CITY OF WILLITS

Re: Draft NPDES Permit No. CA0023060, Order No. R1-2015-0029

City staff has reviewed the draft NPDES Permit No. CA0023060, Order No. R1-2015-0029. On review, these are the comments the City would like to submit to the RWQCB prior to the close of the review period:

TITLE 18" FLUME

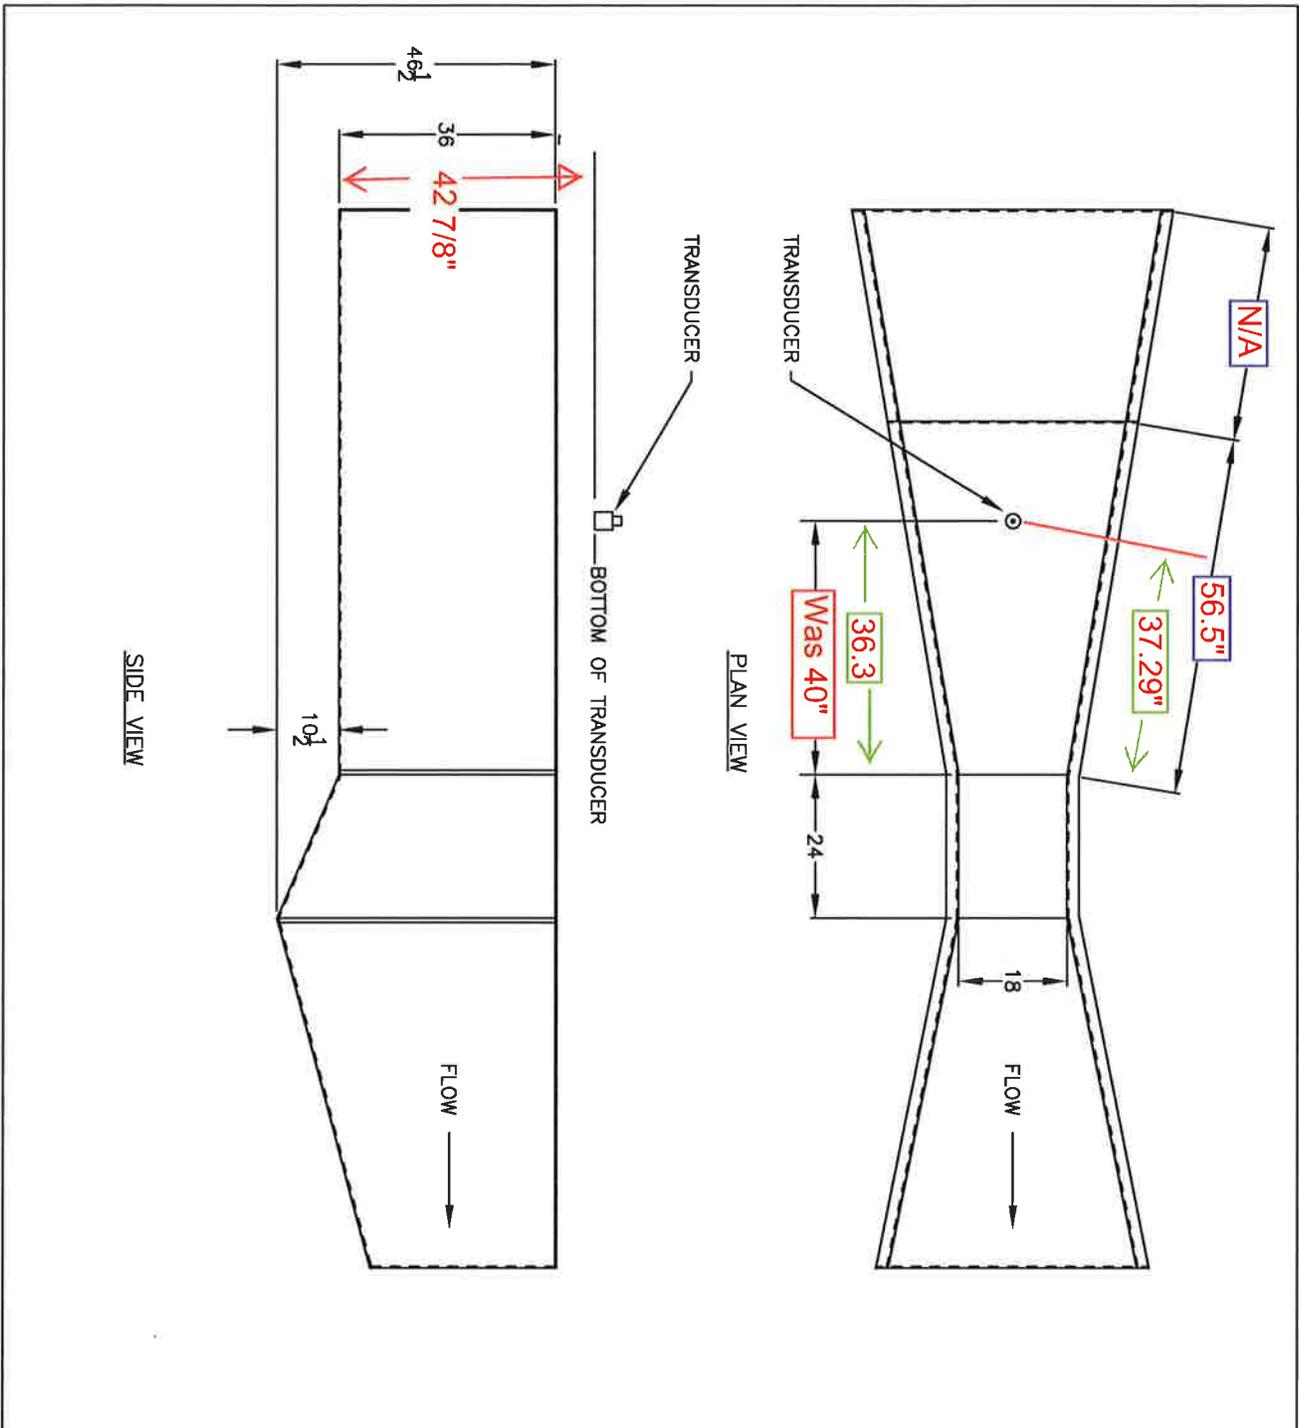
While onsite on the 26th of September, more information was provided which relates directly to this topic. As detailed in the attached drawings, there is a significant installation issue with the installation of the WWTP's influent flowmeter. An elevation discrepancy exists between the flow meter flume's outlet and the piping behind it. This conceivably could cause flow to back-up into the Parshall Flume. This would greatly, and adversely, affect the accuracy of the device. The elevation difference appears to be .27 tenths of a foot. This equates to roughly 360 gpm if my calculations are correct. Combined with the mis-set parameters found in the flowmeter, it seems likely there has been a great deal of flow through this device which has gone unrecorded over the years. Unlike the parameter issue, the issue with the actual installation will be much more difficult to address. While there are tests which can be performed to determine if the flume is suffering from a submergence condition, they would require an amount of labor equal to installing a new flow measurement device. As such, it would be the opinion of MCC CS that the effort would be better directed at procuring and installing a replacement flow measurement instrument that would not be affected by the flume's actual physical installation. MCC CS concurs with the City opinion that a Hach FloDar would work well as the WWTP influent measuring device. Eventually, the best course of action would be to replace entire Parshall Flume with a Magnetic Flowmeter (such as a Siemens Sitrans). These are the world wide industry standard and almost above reproach for accuracy and dependability. Given their factory calibration and the need for zero maintenance after installation, installation of such an instrument would provide a great deal of peace of mind for the City in this application.

- The ultra-sonic transducer appears to be mounted too low. The manufacturer's manual specifies the face be greater than the "blanking distance" from the top of the flume (max head height). This is not the case as our drawing of measured dimensions shows. Blanking distance is set at 12 inches, which is likely near the minimum blanking distance for such a transducer and cannot be reduced. And while maximum head is set in the parameters at 30 inches, the top of the flume is 36 inches. Under normal conditions, this allows a margin of .5 inches. As the influent could get to 36 inches, the current installation is possibly inadequate under some conditions of high flow. It would be advisable to raise the transducer six inches or so if possible. (Blanking distance is the area close to the transducer in which it cannot accurately measure distances and the flowmeter is thus configured to ignore such false readings in that area.)

While we had come equipped to remove and replace the existing conduit and transducer mounting, it was found that the transducer mount was loose enough to allow it to be moved. So the transducer was simply relocated to the proper location and the existing hardware was retained. It should be made clear that "loose" meant the assembly could be moved with an 18" Rigid pipe wrench. It was by no means loose enough to move by hand. The end result was that the transducer location was satisfactorily corrected.

Map of Reclamation Fields

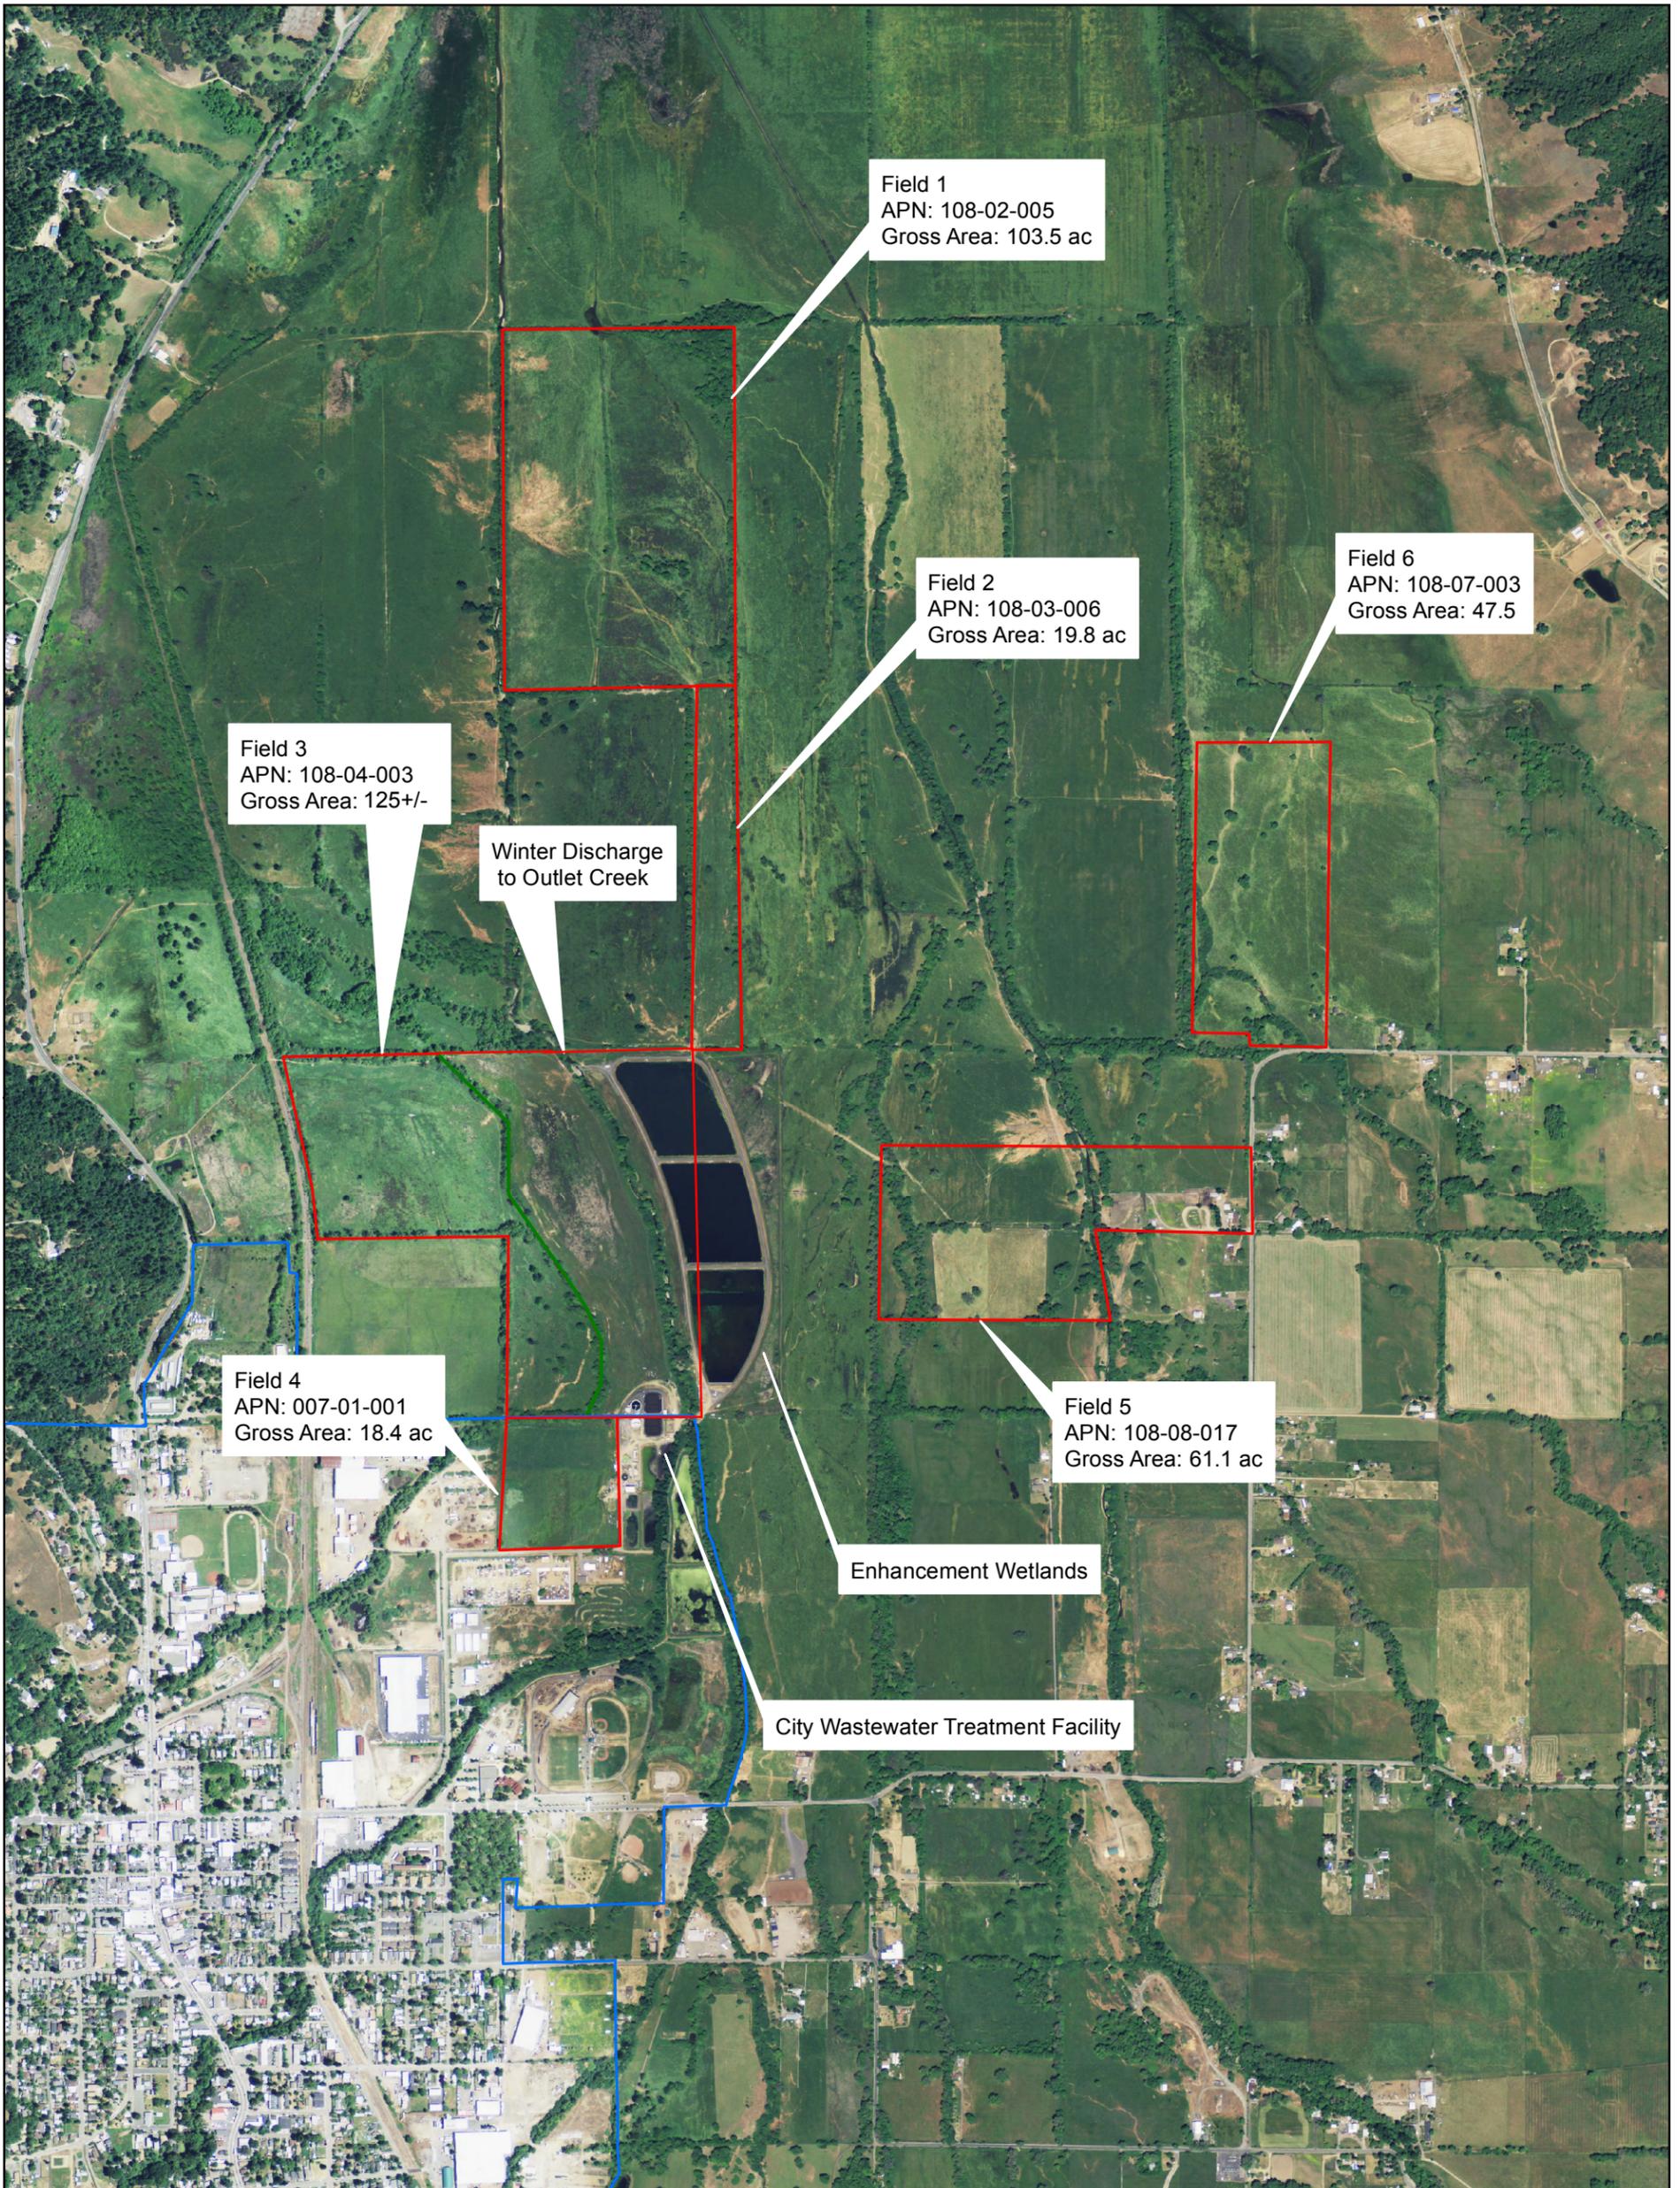
- Staff wishes to clarify the parcels in which we are permitted to irrigate with recycled water. The map on page C-4 needs modification and a revised map is included with this letter as "Revised C-4 Map". The revised map includes a field to the north of the treatment facility, which is part of APN#108-04-003 (identified on the map). Furthermore, we would like to list all parcel numbers we are permitted to irrigate in the new permit as: APNs 108-04-003, 007-01-001, 108-08-017, 108-07-003, 108-03-006, 108-02-005.
